APPLICATION FOR APPROVAL OF MAJOR MODIFICATION/REPAIR

JODEL D.II.

AILERON PULLEY INSTN.

- POSITIVE ATTACHMENT OF MLERON PULLEY MOUNTING
BRACKET.

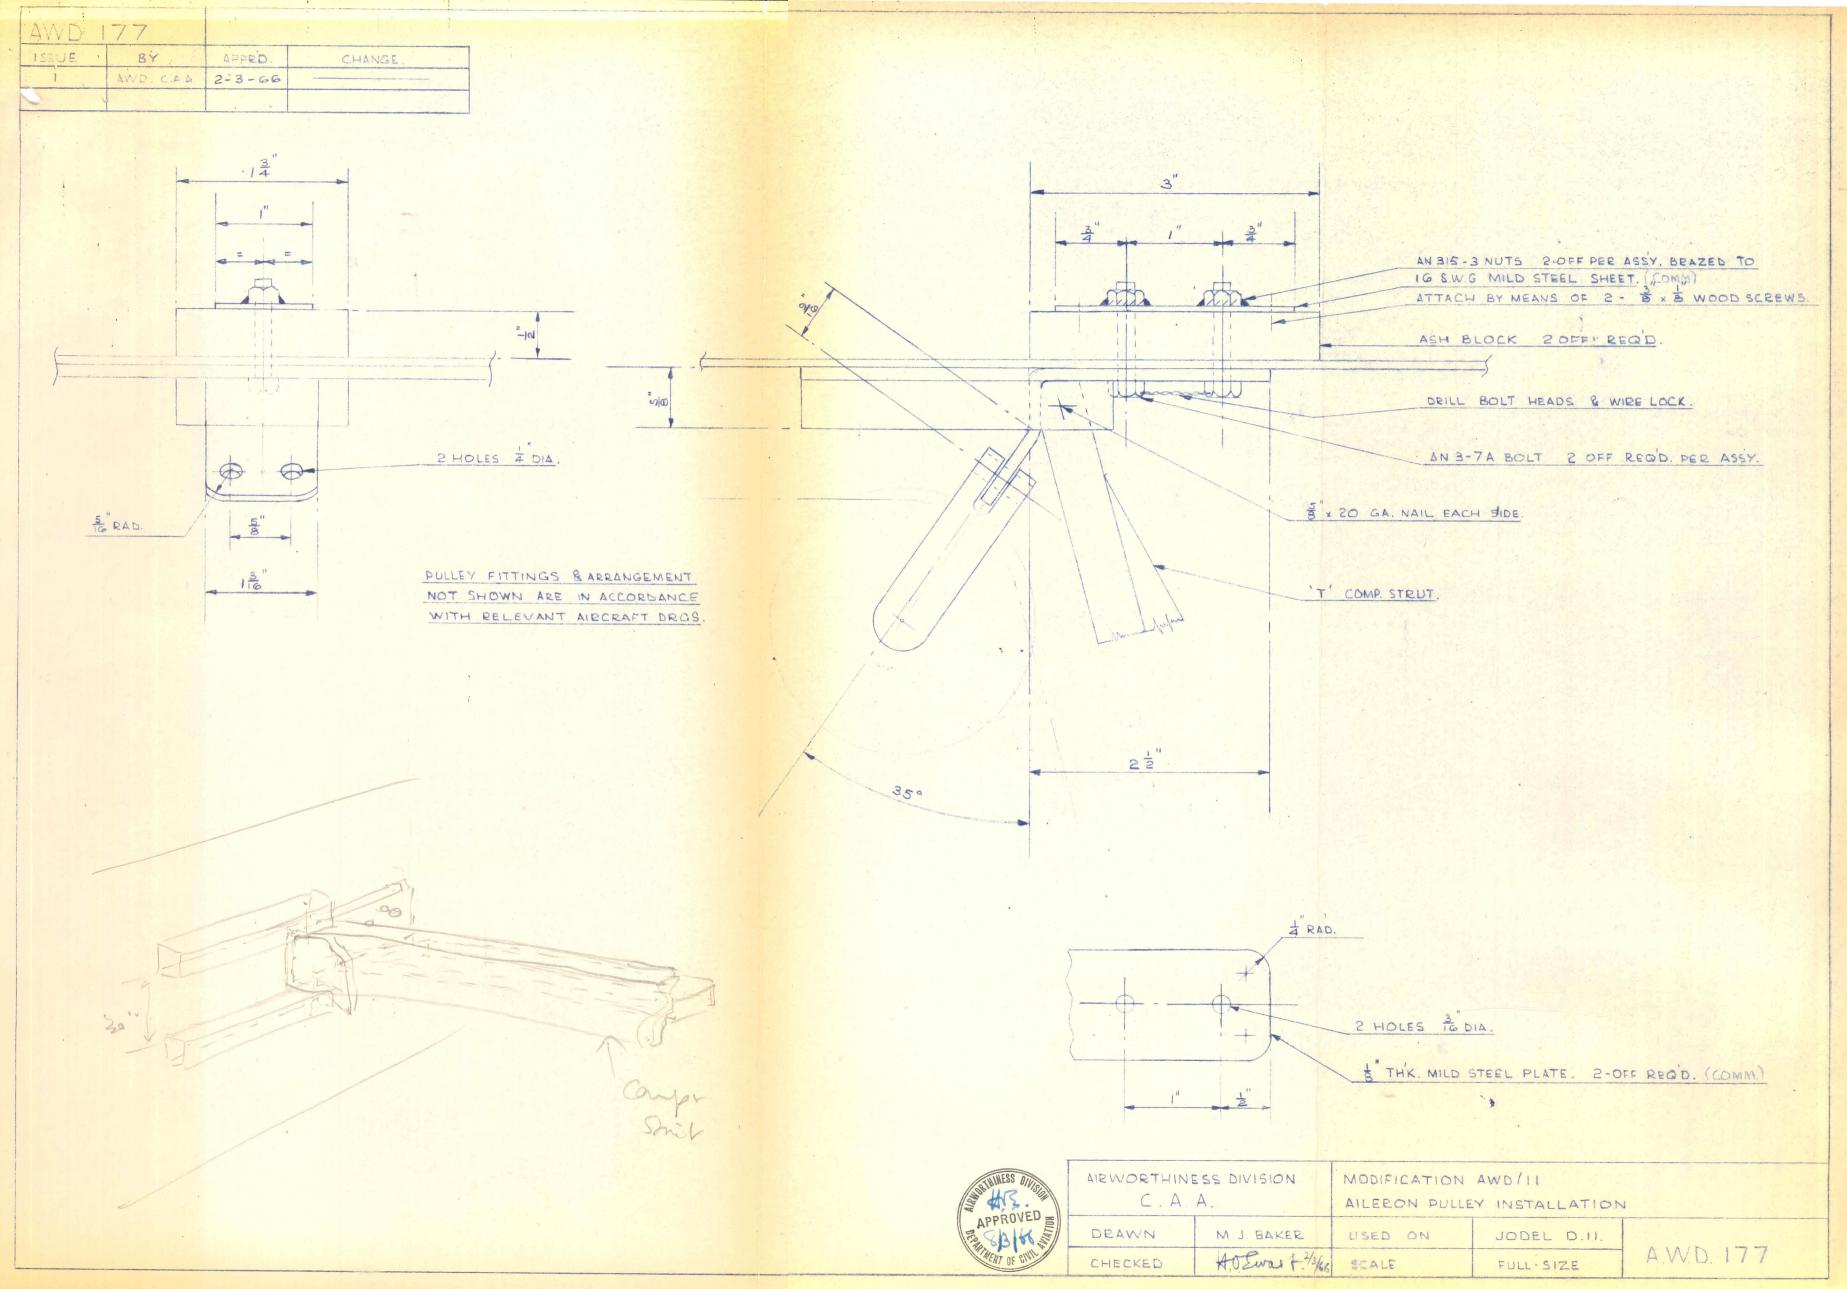
TO PREVENT REPETITION OF PAILURE EXPERIENCED BY D-11 AIRCRAFT IN CANADA.

DRAWING NO AND 177 INTRODUCED.
